AGENDA OF THE PLANNING COMMISSION  
SPECIAL MEETING  
CITY OF BIRCHWOOD VILLAGE  
WASHINGTON COUNTY, MINNESOTA  
March 6, 2025  
6:45 P.M.

**Meeting Date(s):** February 27, 2025 Planning Commission  
March 11, 2025 City Council

Report prepared by Ben Wikstrom, Planning Consultant

# DAVIDSON RESIDENCE LANDSCAPE & HARDSCAPE PLAN

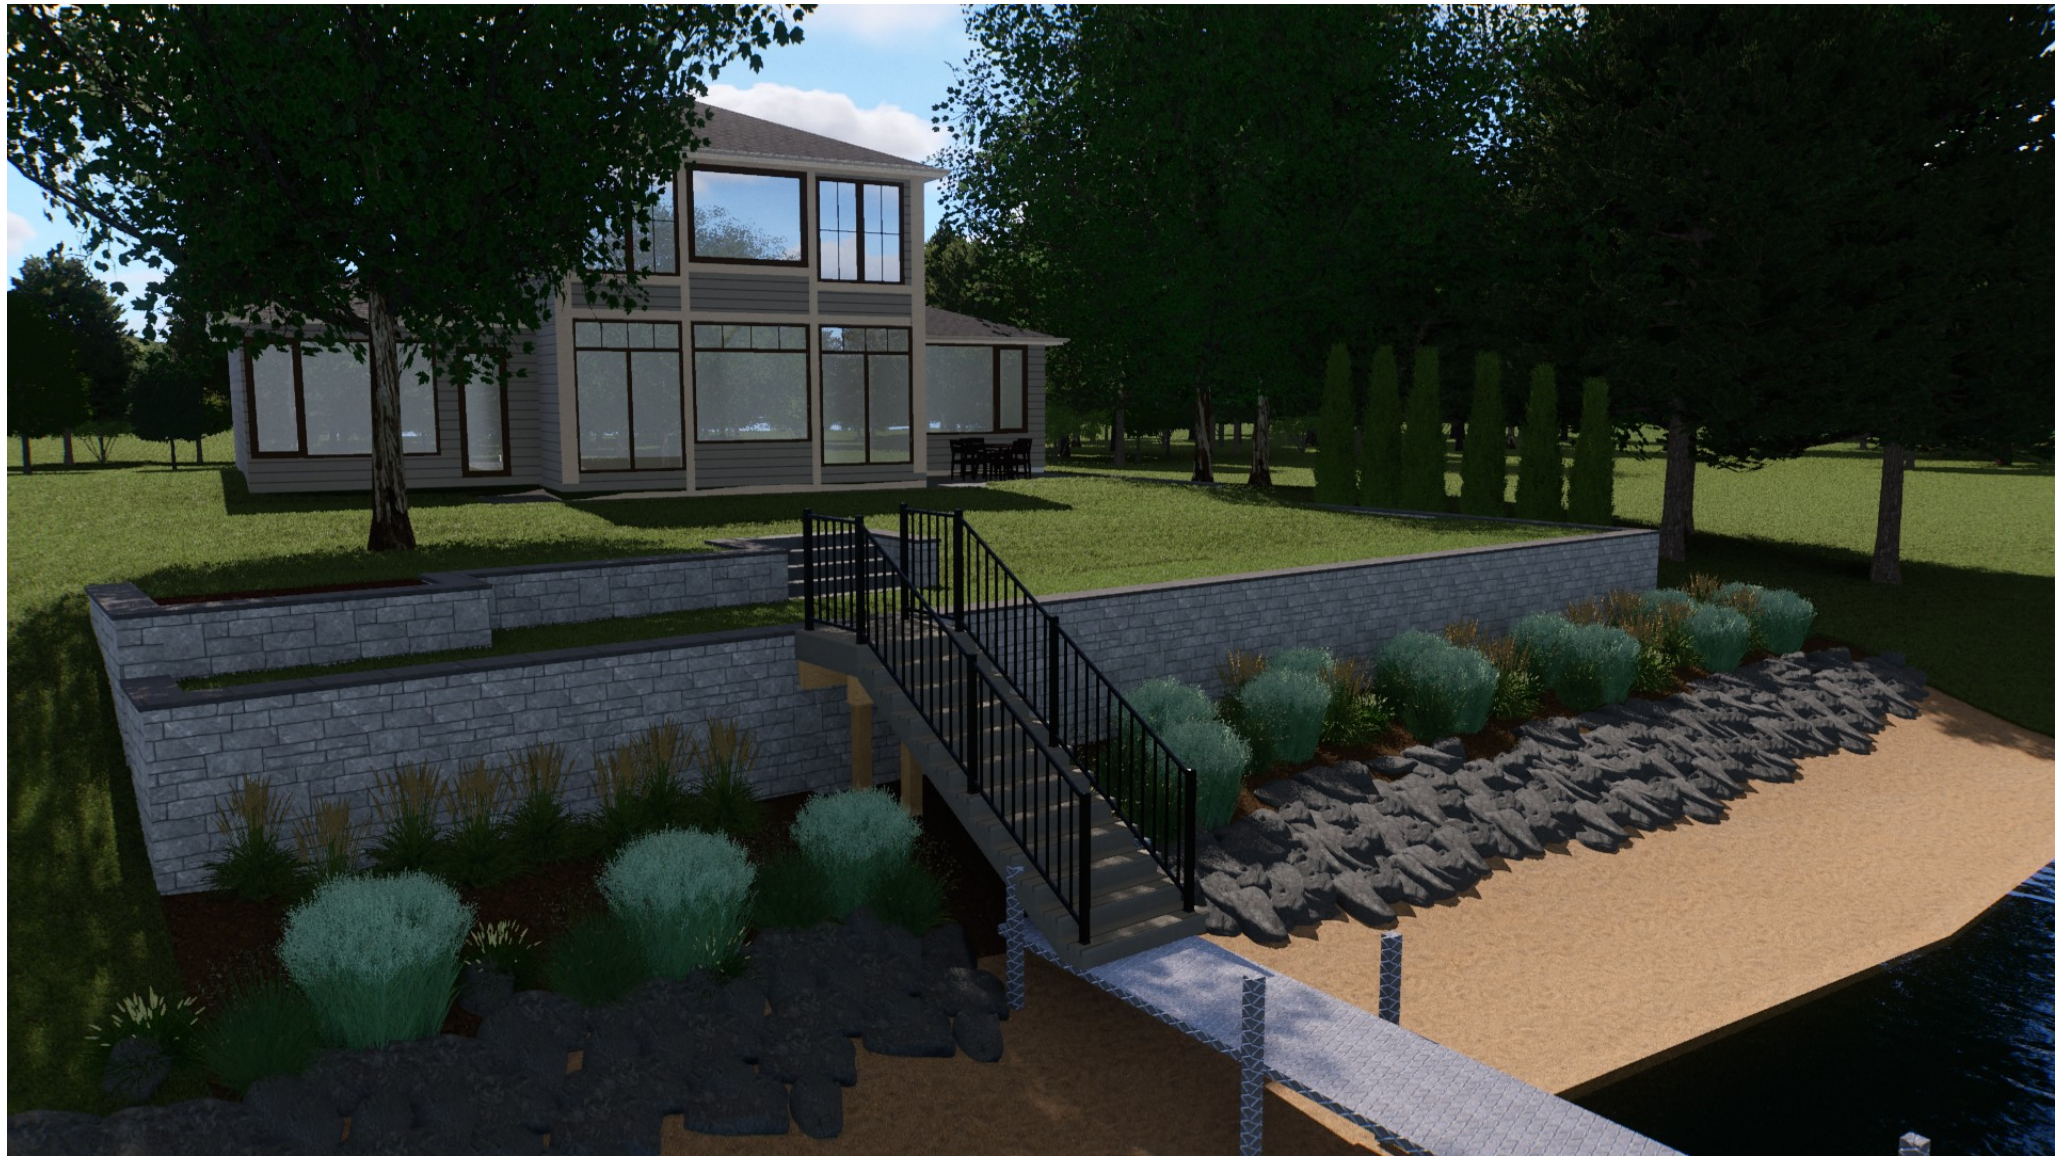
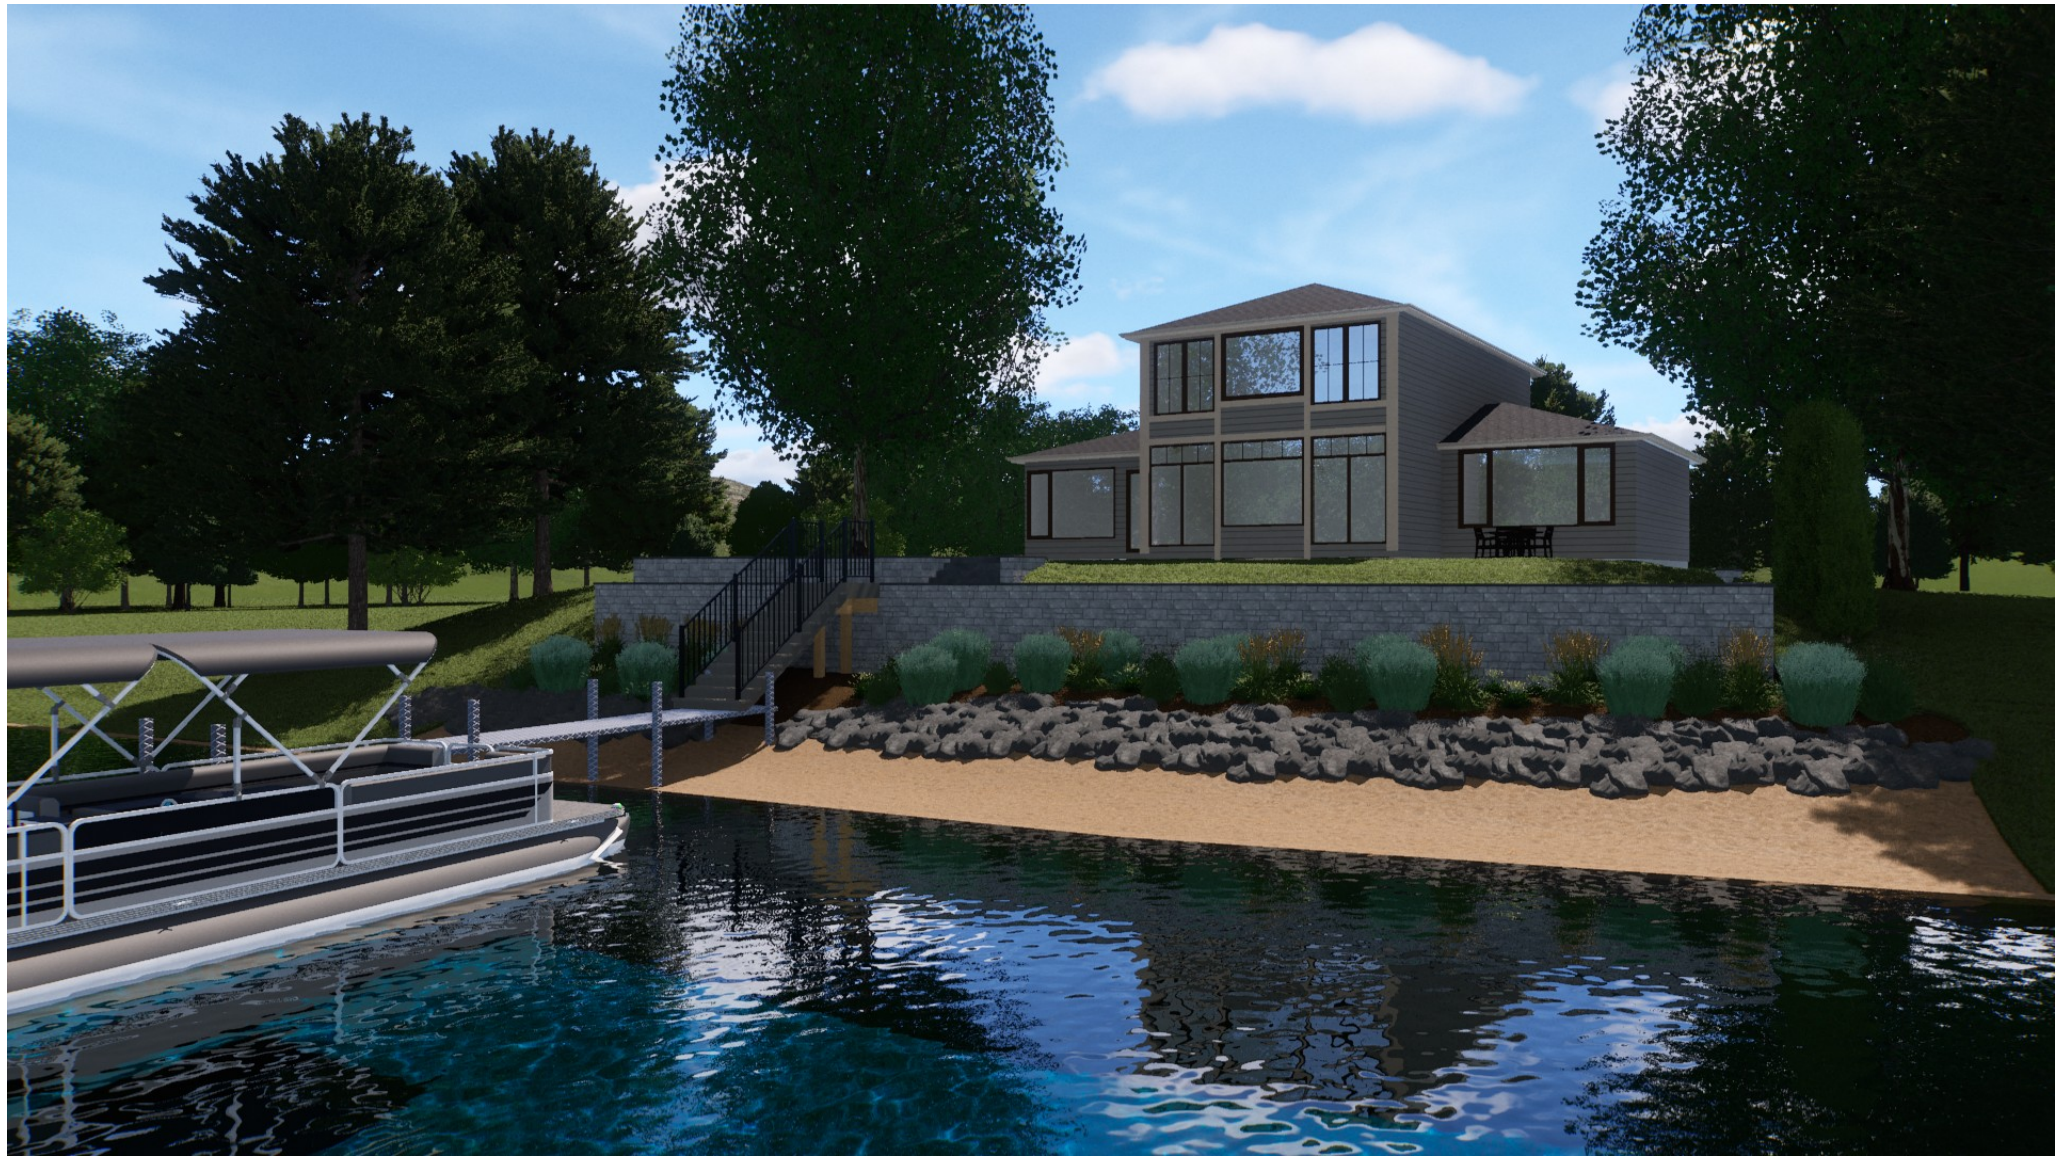
As stated earlier in the report, the design of the wall has changed from a boulder wall (at the time of earlier variance approvals) back to a stone/block and mortar design. The renderings show a good depiction of the proposed materials. One adjacent neighbor was concerned with the height of the wall and hard corner near their property, but the City Council approved a variance to the wall height and was appeased by the change to a boulder wall. In a letter outlining the findings for approval, no mention of the boulder-type construction was made, so the applicant can change the design. However, if the commission or council believes this will have a negative impact on the character of the neighborhood as it relates to the current applications, a discussion of the design should ensue.
